Citadel Update

September 2008

New Hardware!

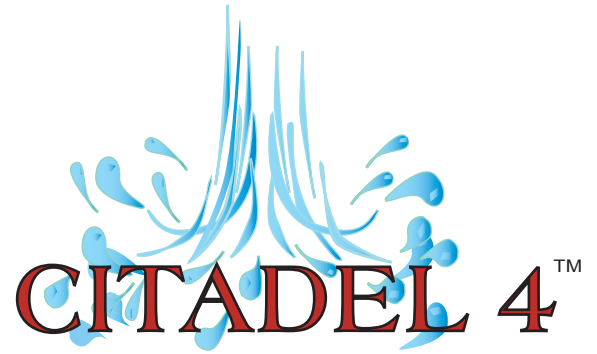
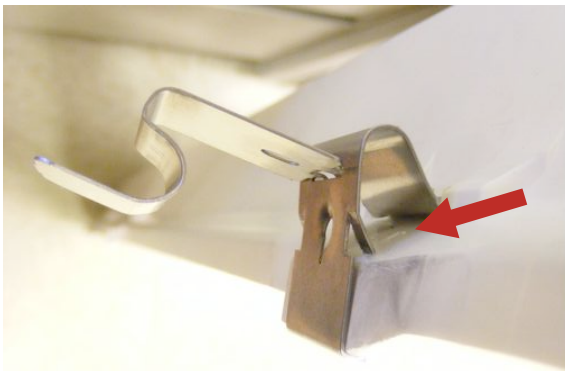
The Citadel 4 has a new and improved latch! The new latch engages with the housing and provides positive support for the lens, without the potential to flex. Another feature on this new latch is its ability to lock tightly into place. Preventing the possibility of breaking loose and falling off.

Installing the new latch is also different. The latch hooks from the bottom of the housing and pops the dove tail into place. For more indepth instructions visit www.slplighting.com and click Technical Information on the Citadel 4 page.
